## **ALAYNA'S SHORELINE SUBDIVISION**

APPLICATION NUMBER 5 DATE September 15, 2016

REQUEST Subdivision

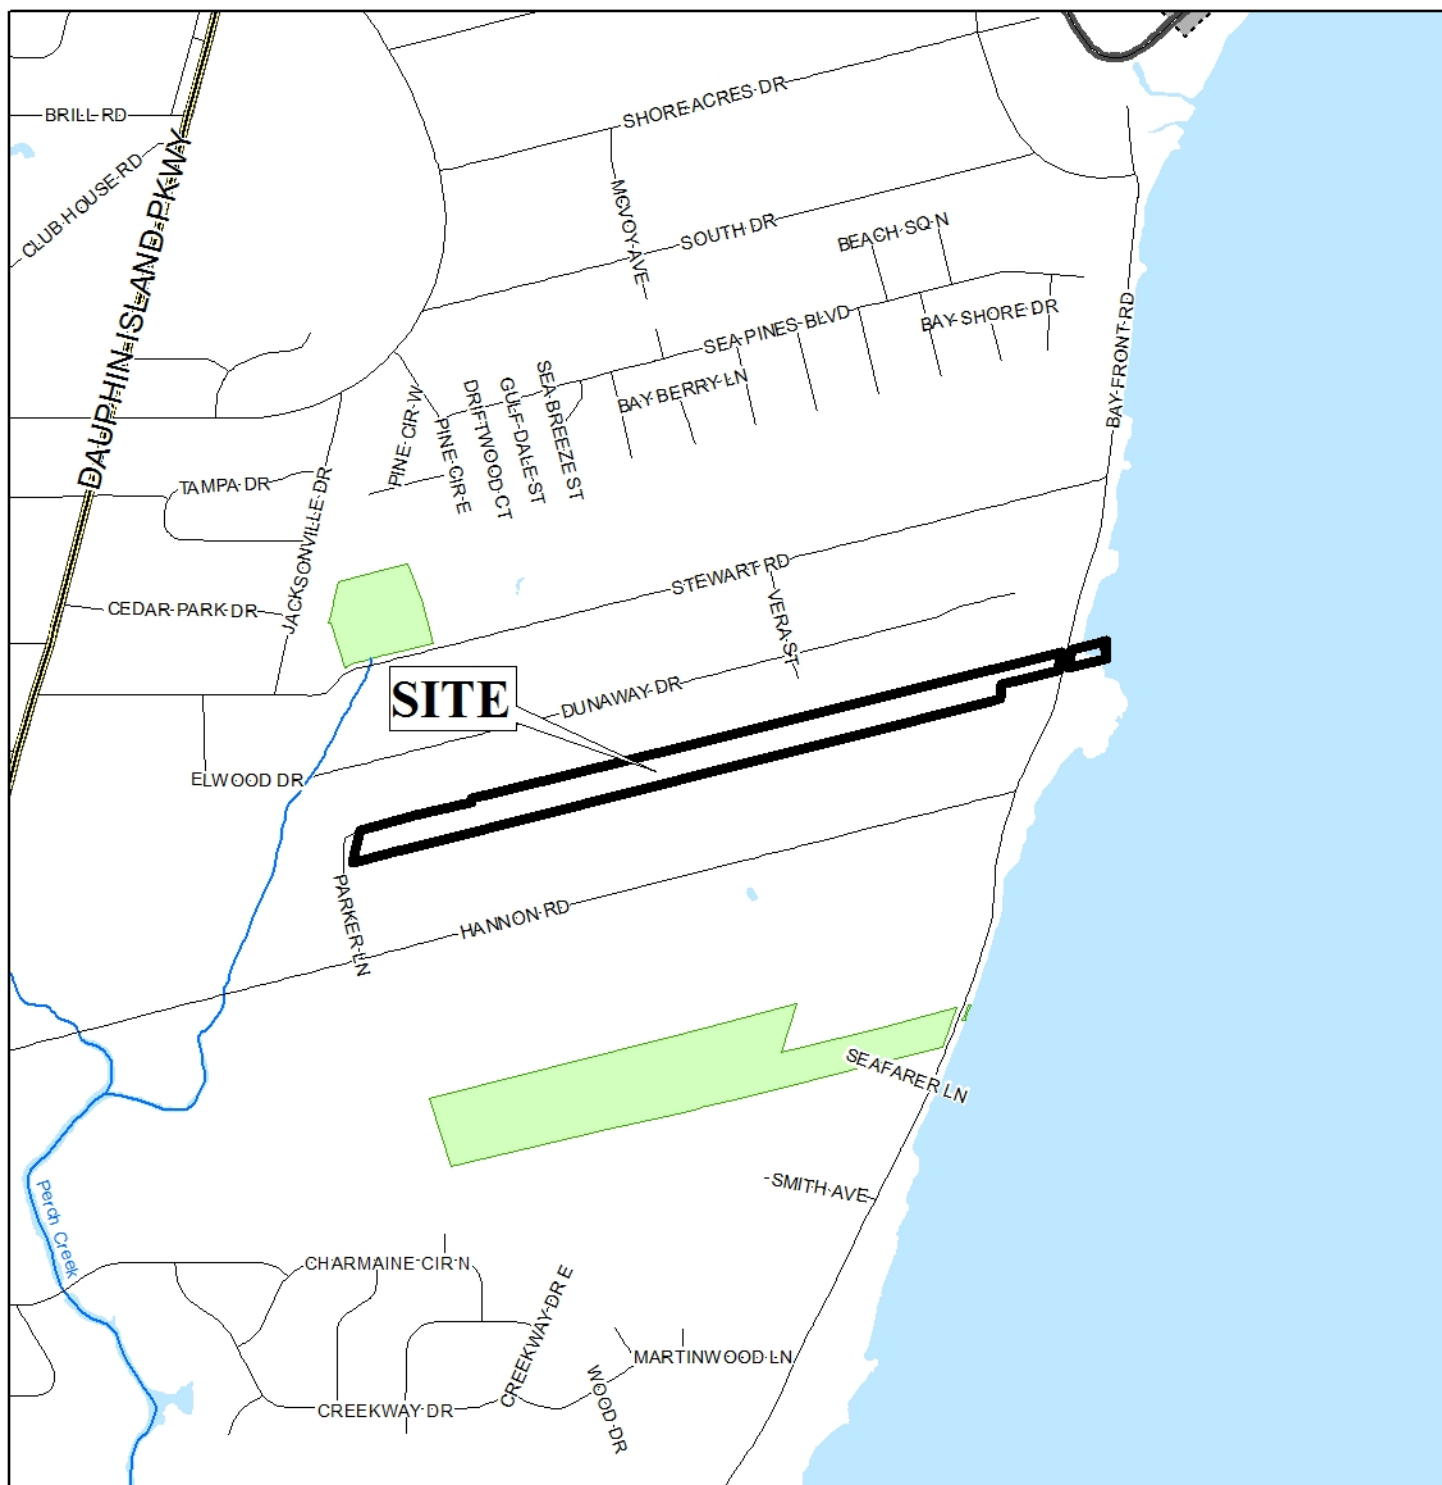
- A. Provide all of the required information on the SUBDIVISION PLAT (i.e. signature blocks, signatures, certification statements, written legal description, required notes, legend, scale, bearings and distances) that is required by the current Alabama State Board of Licensure for Professional Engineers and Land Surveyors.

- B. Add legible street names to the vicinity map.
- C. Show the east end of Parker Lane ROW and existing parcels adjacent to the north line of LOT A.
- D. Review and revise the written legal description. Check the labeling and limits of existing LOT 2 and the use of it in the written description.

- E. Add all written bearings in the written legal description to the map.
- F. Label the POC and POB of each parcel.
- G. Check the callout for the distance across Bay Front Rd. Written value doesn't match the map.

- H. Provide reference monumentation along the East side of LOT B.
- I. Dedicate ROW along Parker Lane as required (approximately 10') to match the Channel View Subdivision to the south and a corner radius (25' minimum or as approved by the City Engineer and Traffic Engineer) at the Northwest corner of LOT A.

- J. Show and label all flood zones.
- K. Show and label the MFFE (Minimum Finished Floor Elevation) on each lot that contains an AE, V, or X (shaded) flood zone designation.

- L. Provide and label the monument set or found at each subdivision corner.
- M. Show and label the existing monumentation for the northwest corner of Channel View Subdivision that lies along the south property line of the proposed subdivision.

Proposed Lot A has frontage on Parker Lane, a minor street without curb and gutter that would traditionally require a 60' right-of-way width; however, the preliminary plat illustrates a 30' right-of-way width along Parker Lane. Given that a neighboring subdivision, approved at the September 15, 1994 meeting of the Planning Commission, was required to dedicate the appropriate right-of-way width along Parker Lane, the subject plat should be revised to also illustrate dedication of 30' from the centerline of Parker Lane, if approved.

Proposed Lot B is slightly irregular in shape and may perhaps be regarded as a flag lot. Additionally, the depth of each proposed lot is more than 3.5 times the width of the lots at their potential building setback lines. Such designs are generally discouraged by Sections V.D.1 and V.D.3. of the Subdivision Regulations, respectively; however, the lots are not incompatible with other lot configurations in the vicinity, many of which were approved by the Planning Commission. As such, a waiver of Sections V.D.1. and V.D.3. of the Subdivision Regulations may be appropriate.

The 25-foot minimum building setback is not illustrated on either lot on the preliminary plat. Revision of the plat to illustrate a 25-foot minimum building setback line on each lot, along each street frontage, should be required, if approved.

It should be noted that, with regards to the portion of proposed Lot B to the East of Bay Front Road, similarly-split lots in the vicinity have been approved with the condition that no dwellings are permitted to be constructed on such lot portions. As such, a similar condition of approval for the proposed subdivision may be appropriate.

- 1) revision of the plat to dedicate 30' from the centerline of Parker Lane along Lot 1;
- 2) placement of a note on the Final Plat stating that Lot A is limited to one curb cut to Parker Lane, and Lot B is limited to one curb cut on either side of Bay Front Road, with any changes in their sizes, designs, or locations to be approved by Traffic Engineering and conform to AASHTO standards.

- 4) revision of the plat to illustrate a 25' minimum building setback line along all street frontages;
- 5) placement of a note on the Final Plat stating no dwelling may be constructed on the portion of Lot B East of Bay Front Road;
